ADDENDUM

PROJECT: Forestside Estates
Attmar & Palleschi Drive
Brampton, Ontario

ADDENDUM NO. M-2

PURPOSE: To match Architectural changes and coordination as discussed on coordination meeting.

DATE	PROJECT	DRAWING
MAY, 2019	18-017	M-4B

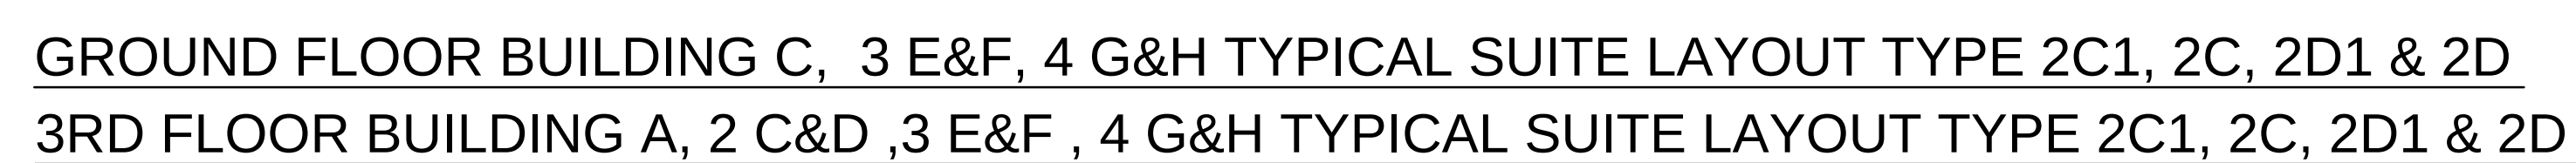
10.0 Mechanical drawing M-4B (Parking Level - HVAC – Mechanical-Part 2) Issued

10.1 Revised: HVAC layout as indicted.

DRAWN MC	CHECKED LM	SCALE 1:50
DATE MAY, 2019	PROJECT 18-017	DRAWING M-47
		OF

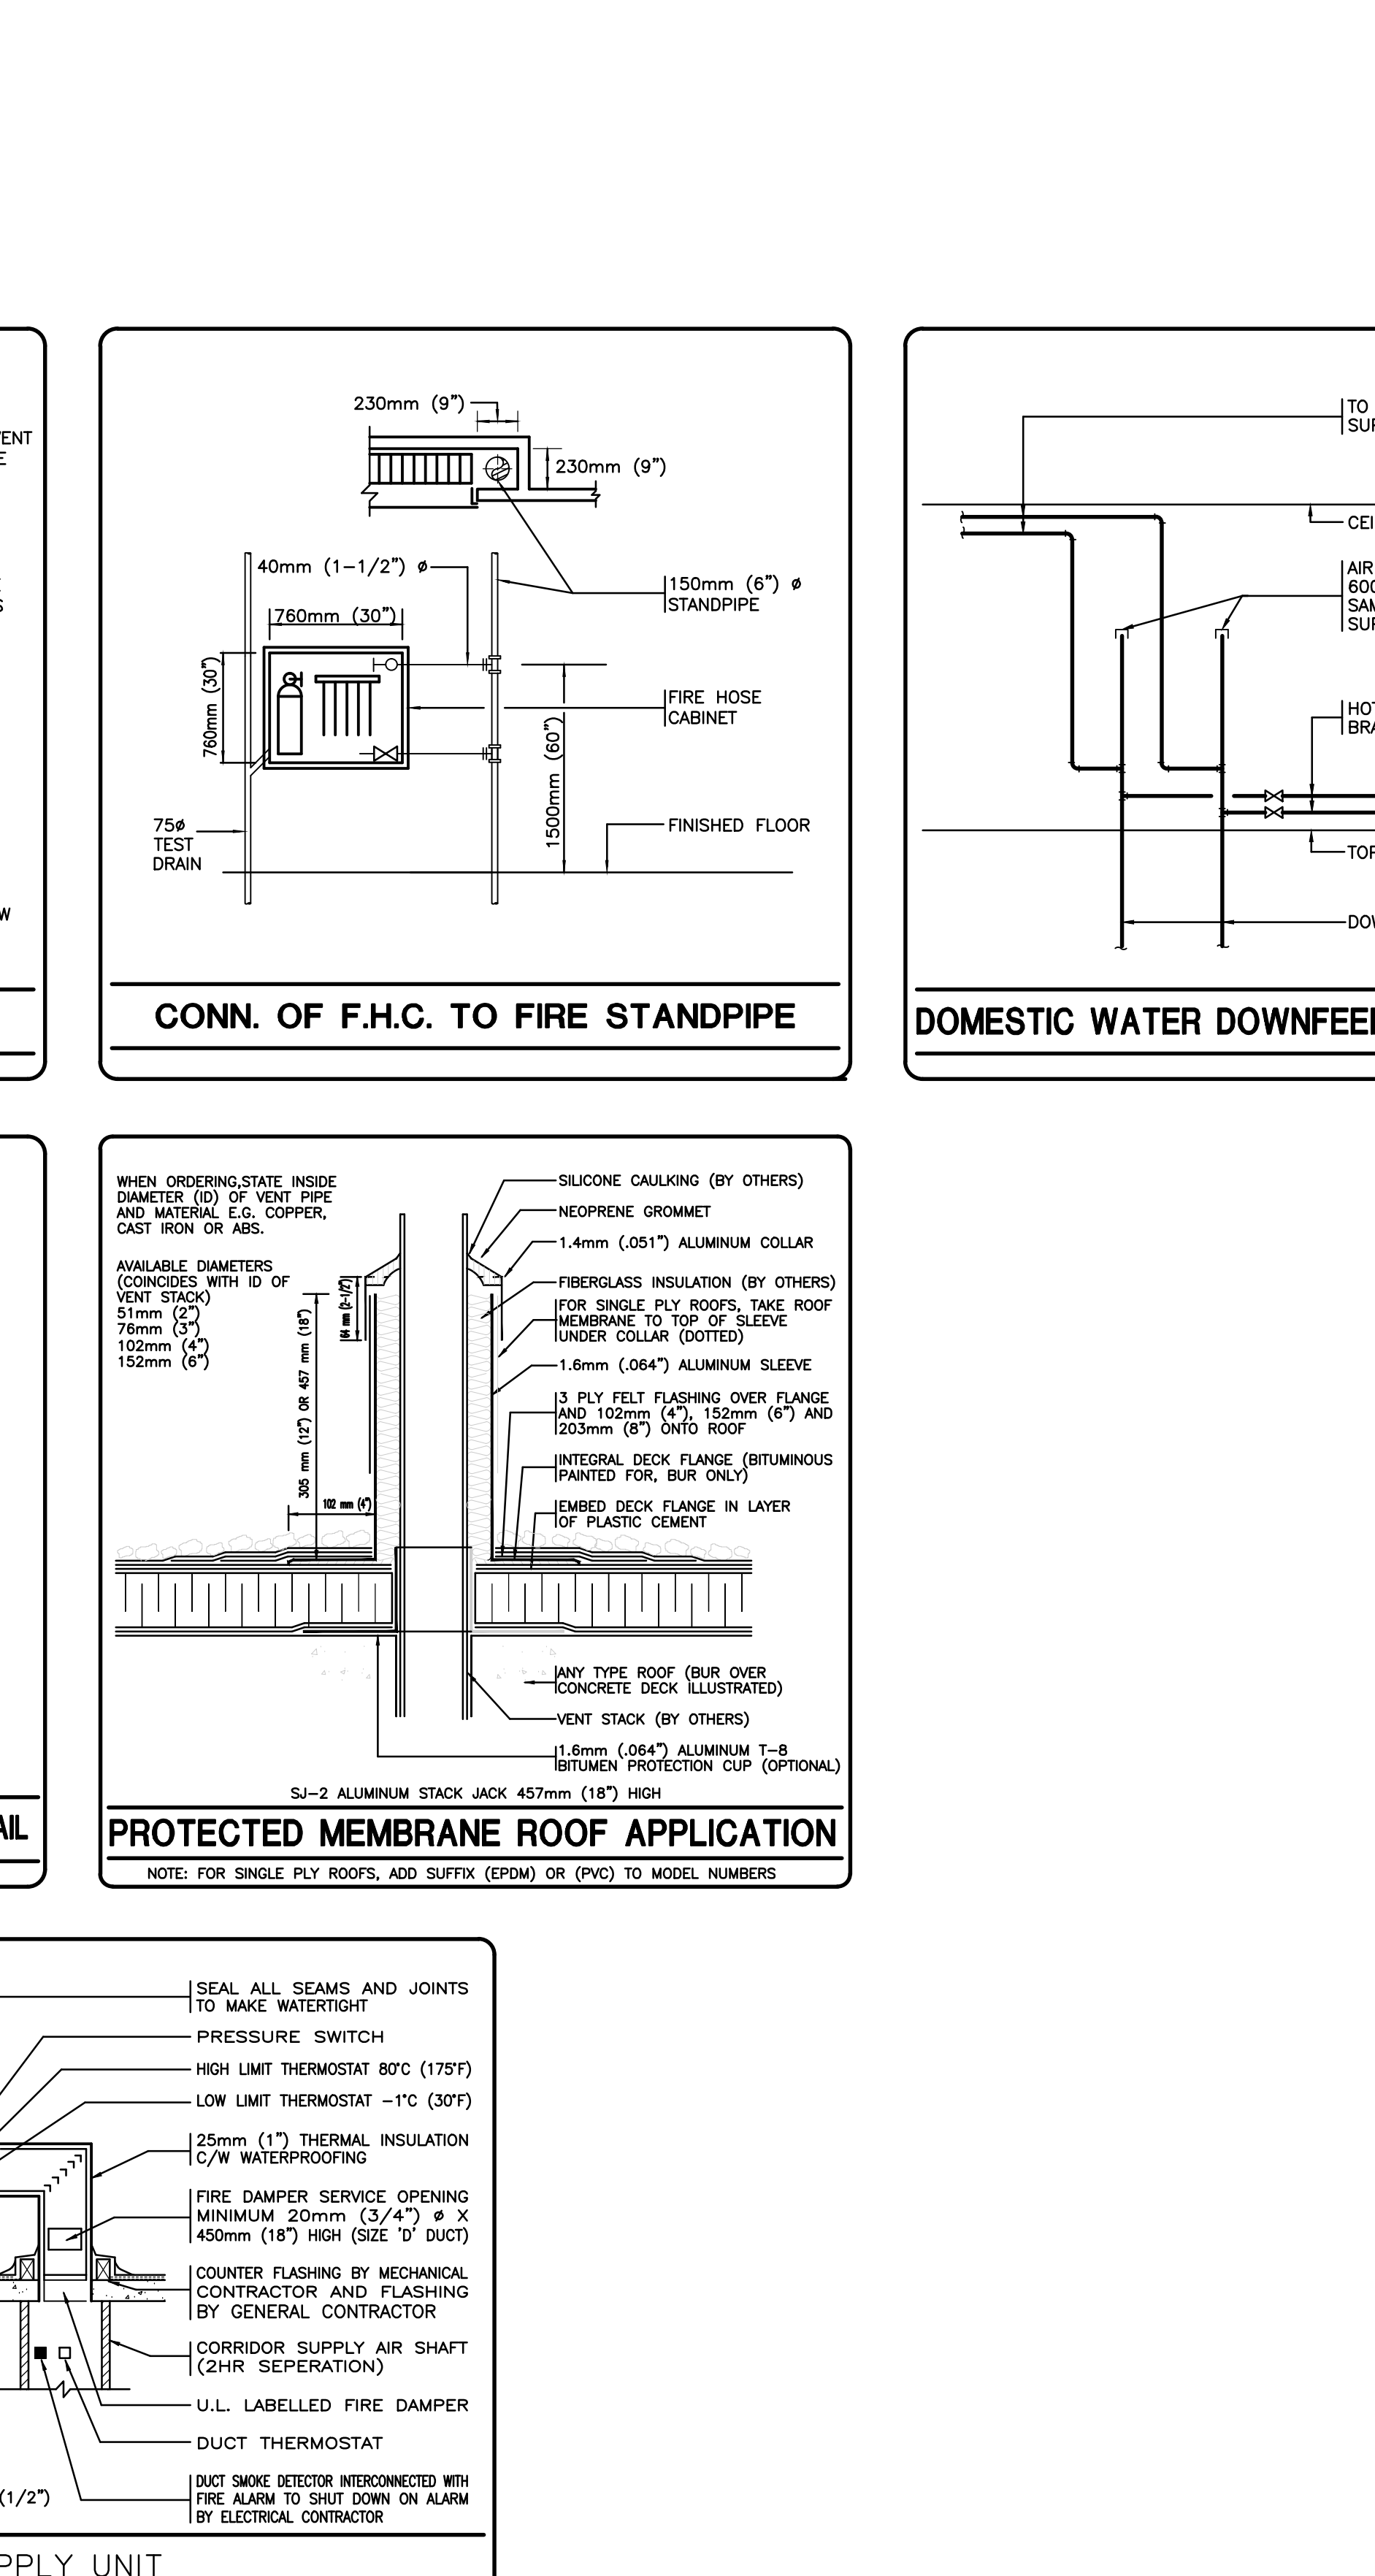
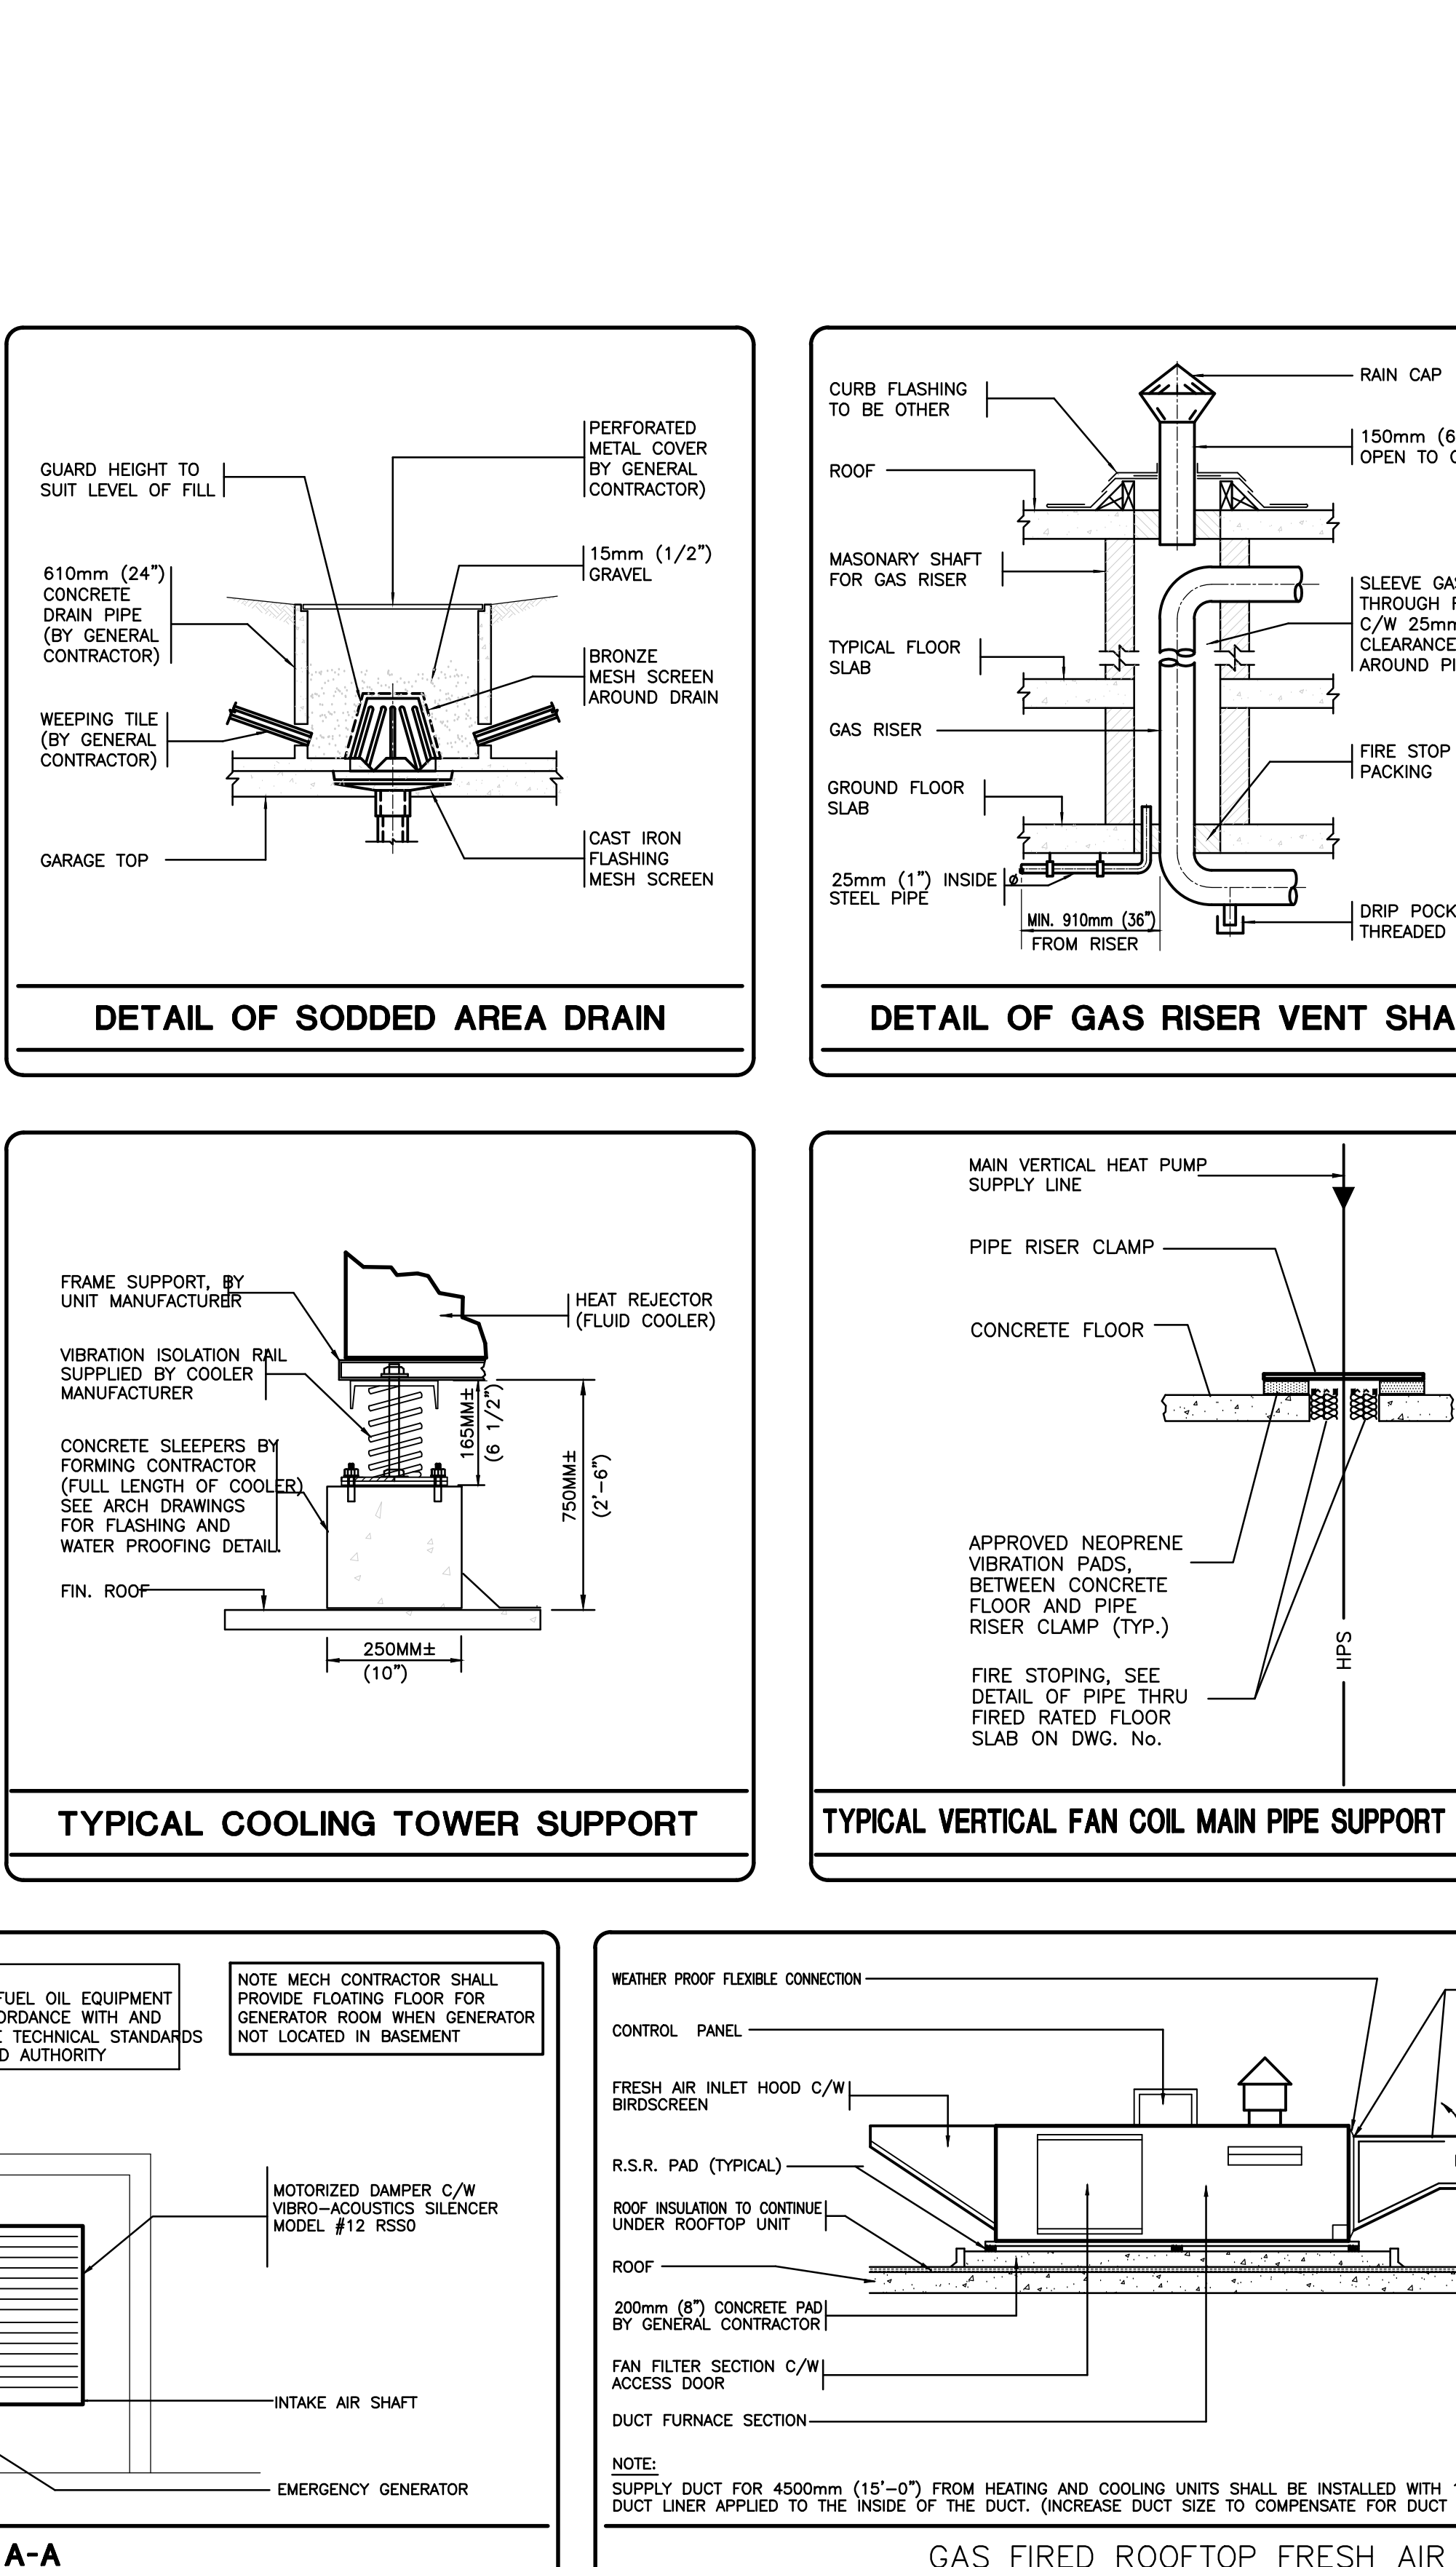
12.0 Mechanical drawing M-47 ((Typical Suites Layout - Mechanical) Issued

12.1 Revised: Ductwork and diffuser layouts as indicated.
